South Texas Project Electric Generating Station 4000 Avenue F – Suite A Bay City, Texas 77414

July 24, 2008
ABR-AE-08000055

South Texas Project
Units 3 and 4
Docket Nos. 52-012 and 52-013
Response to Requests for Additional Information

Attached are responses to NRC staff questions included in Request for Additional Information (RAI) letter numbers 33, 39, 40, 49, and 50 related to Combined License Application (COLA) Part 2, Tier 2 Sections 2.4S and 2.5S. This submittal includes responses to the following Questions:

Figure 2.5S.2-7 Southern Boundary of EPRI Incompleteness Regions (Reference 2.5S.2-3) (Table 5-1 of Reference 2.5S.2-16) and Gulf of Mexico Seismicity Recurrence Area (Re-Focus Zone)

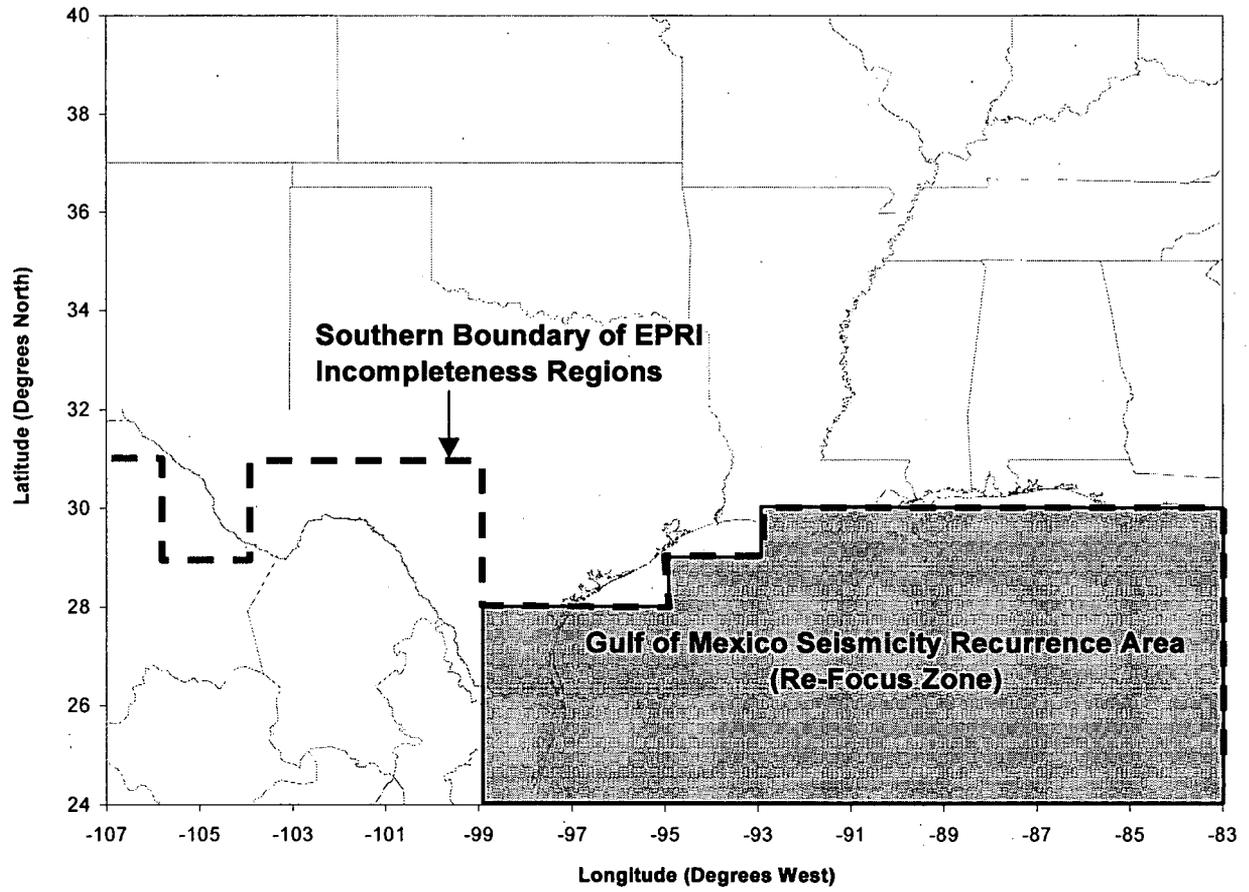
The caption for Figure 2.5S.2-7 cites Reference 2.5S.2-3 as the source for the southern boundary of the EPRI incompleteness regions. Judged by its shape, however, the boundary plotted in Figure 7 appears different than the boundary plotted in Figure 4.4 of the cited reference. Please reconcile the apparent differences in the plotted boundaries.

The reference cited in the caption for Figure 2.5S.2-7 should have read “Table 5-1 of Reference 2.5S.2-16,” not “Reference 2.5S.2-3.”

The southern boundary of the EPRI incompleteness regions presented in Figure 4-4 of Reference 2.5S.2-3 is different in at least two ways from that presented by Table 5-1 of Reference 2.5S.2-16, the basis for Figure 2.5S.2-7 of the FSAR. First, upon inspection of Figure 4-4, it is apparent that there is a problem in this figure with the longitude markings – they are shifted towards the east – e.g., the middle of Florida should be centered about 82°W. Figure 5-2 from Reference 2.5S.2-16 is similar to Figure 4-4 of Reference 2.5S.2-3, but does not appear to have the problem with the shifted longitude markings.

The caption for Figure 2.5S.2-7 will be changed as follows:

Figure 2.5S.2-7 Southern Boundary of EPRI Incompleteness Regions (~~Reference 2.5S.2-3~~) (~~Table 5-1 of Reference 2.5S.2-16~~) and Gulf of Mexico Seismicity Recurrence Area (Re-Focus Zone)
